Access Compliance Report

Public Rights-of-Way

Intersection ID: 50638	Main Street: RUBY_VALLEY_RD	Cross Street: BLUE_GROVE_RD	Location: SE
ADA ID: 71596AE1C857	Ramp Type: Perp	Initial Pass/Fail: Fail	Overall Compliance: No
		Severity Score: 12.5

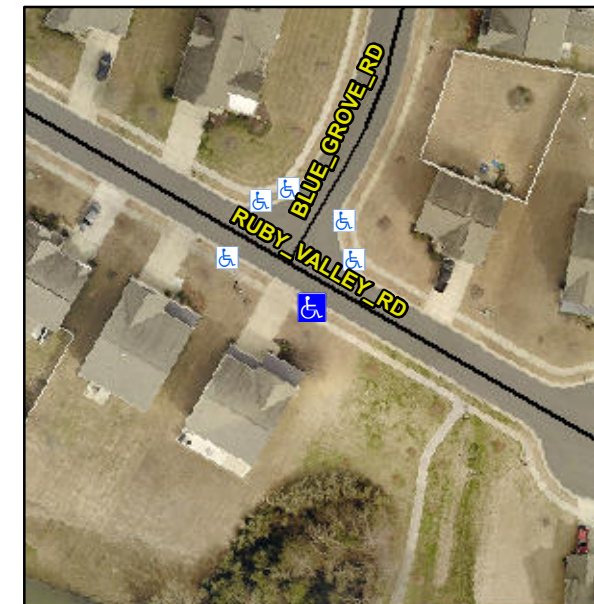
Not Found, R304.2.2

Compliance	Description	Data	Compliance	Description	Data
N/A	Ramp Length (in)	46.5	No	Ramp Slope (%)	9.7
Yes	Ramp Width (in)	48.0	Yes	Ramp XSlope (%)	1.8
N/A	Flare Type LT	N/A	N/A	Flare Type RT	N/A
N/A	Flare Slope LT (%)	N/A	N/A	Flare Slope RT (%)	N/A
N/A	Flare Traversable LT?	N/A	N/A	Flare Traversable RT?	N/A
N/A	Landing Length (in)	N/A	N/A	DWS Provided?	N/A
N/A	Landing Width (in)	N/A	N/A	DWS Contrast?	N/A
N/A	Landing Slope (%)	N/A	N/A	DWS Length (in)	N/A
N/A	Landing X Slope (%)	N/A	N/A	DWS Full Width?	N/A
N/A	Landing Curb? (Y/N)	N/A	N/A	DWS Offset (in)	N/A
N/A	Shared Landing?	N/A			
N/A	Gutter Ponding?	N/A	N/A	Gutter Slope (%)	N/A
N/A	Gutter Lip Ht (in)	N/A	N/A	Gutter X Slope (%)	N/A
N/A	Painted X Walk1?	No	N/A	Painted X Walk2?	N/A
	X Walk 1 Direction	To NE		X Walk 2 Direction	N/A
N/A	X Walk 1 Width (in)	N/A	N/A	X Walk 2 Width (in)	N/A
	X Walk 1 Slope (%)	3.5		X Walk 2 Slope (%)	N/A
	X Walk 1 X Slope (%)	1.0		X Walk 2 X Slope (%)	N/A

Remove & Replace Entire Ramp.
